Subject: Transmittal of the Long-Term Surveillance Plan for the Falls City, Texas,
Disposal Site

Long-Term Surveillance Plan for the U.S. Department of Energy Falls City Uranium Mill Tailings Disposal Site Falls City, Texas

SUBJECT: REVIEW OF DRAFT REVISED LONG-TERM SURVEILLANCE PLAN FOR THE
U.S. DEPARTMENT OF ENERGY FALLS CITY URANIUM MILL TAILINGS
DISPOSAL SITE, FALLS CITY, TEXAS

**TECHNICAL EVALUATION REPORT
DRAFT REVISED LONG -TERM SURVEILLANCE PLAN
FOR THE U.S. DEPARTMENT OF ENERGY
FALLS CITY URANIUM MILL TAILINGS DISPOSAL SITE,
FALLS CITY, TEXAS**

Figure 2. Ground Water Monitor Wells at the Falls City Disposal Site (Figure 2-5 from DOE, 2006a)

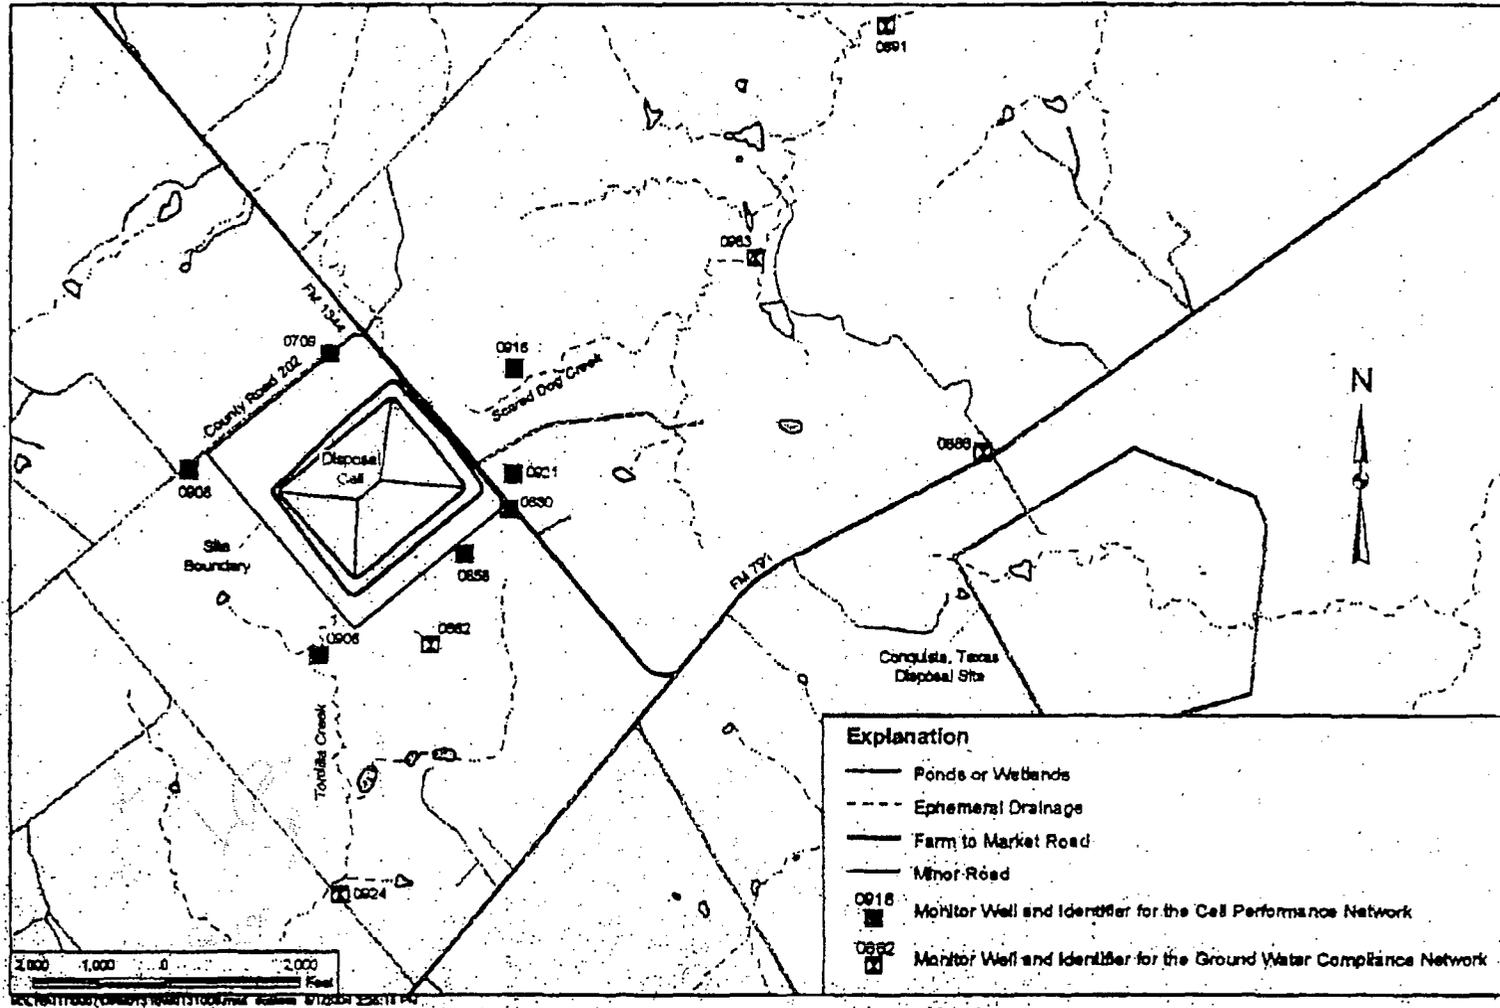
The performance cell monitoring and the GCAP monitoring wells are delineated in Figure 2. The performance cell monitoring network consists of 7 wells (0709, 0858, 0880, 0906, 0908, 0916, and 0921) surrounding the disposal cell and screened in the Deweesville and Conquista aquifer. Monitor wells 0908 and 0916 are located updip of the intersection of the typical water table and the bottom of the Deweesville and Conquista aquifer; therefore, these wells are usually dry. Ground water samples are collected biannually from these wells, and they are analyzed for the analytes listed in Table 1 (DOE, 1997b and DOE, 2006b).

Figure 3. Ground Water pH in the Deweesville and Conquista Aquifer (Figure 2-7 from DOE, 2006a)

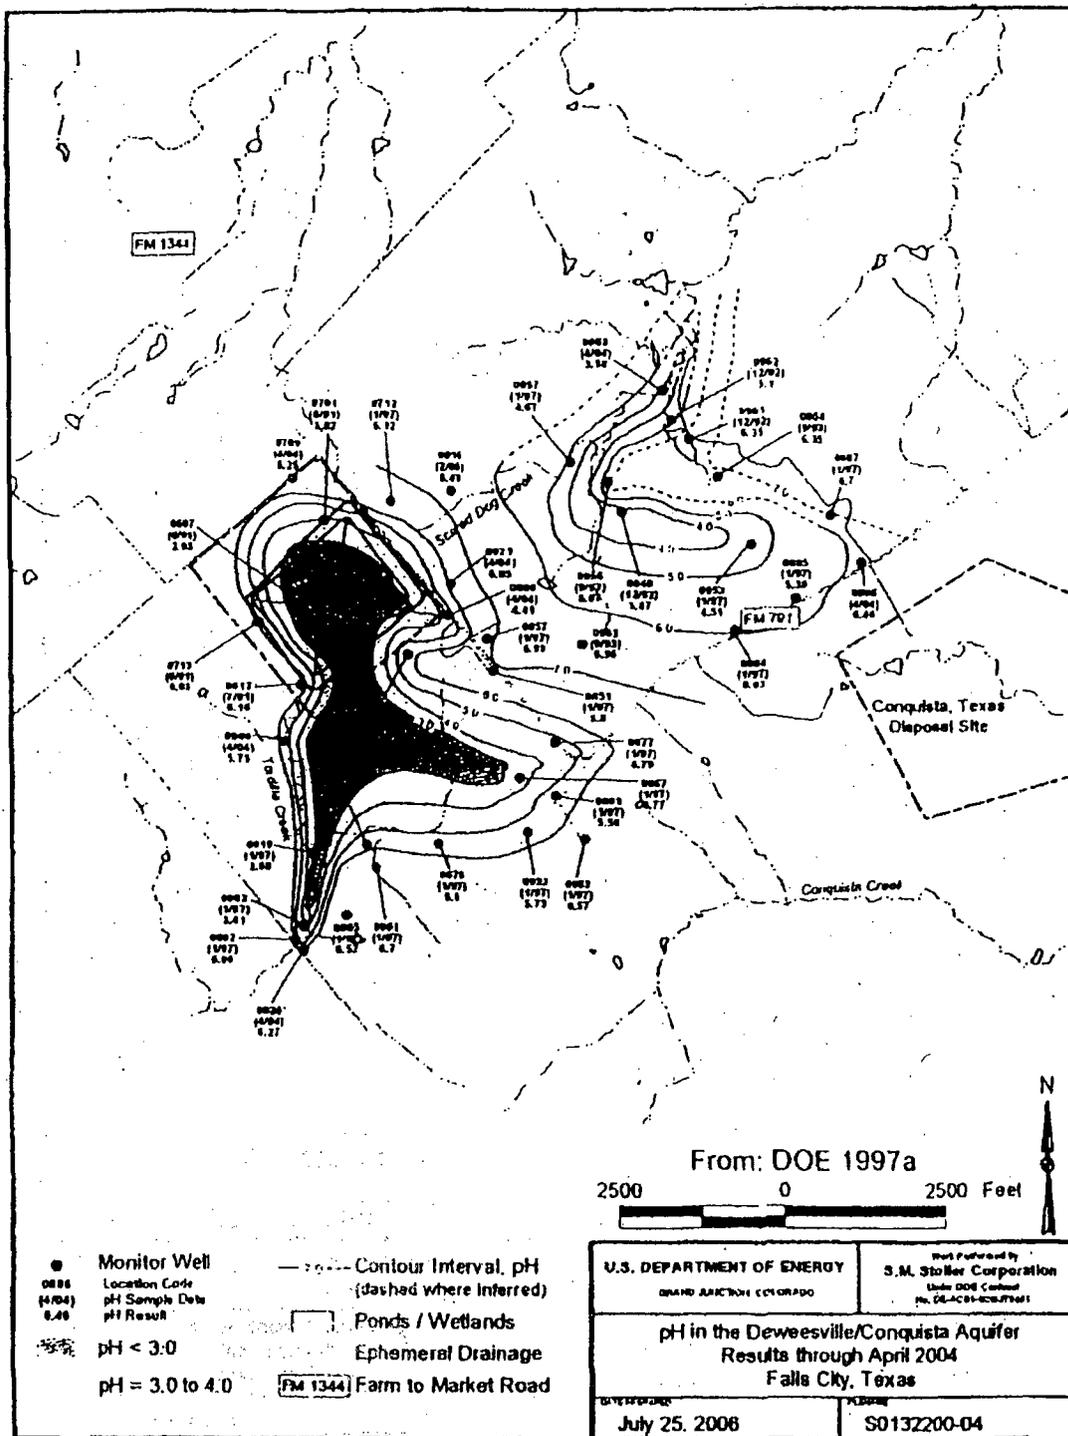
Figures 3 and 4 delineate the pH in the Deweesville and Conquista aquifer and Dilworth aquifer, respectively. The pH isopleths on these figures are surrogates for uranium and some of the other metals listed in Table 1. Figure 3 shows that there are two areas of lower pH, which would represent uranium plumes in the Deweesville and Conquista aquifer. Figure 4 indicates that there is one area of lower pH, which would represent a uranium plume in the Dilworth aquifer.
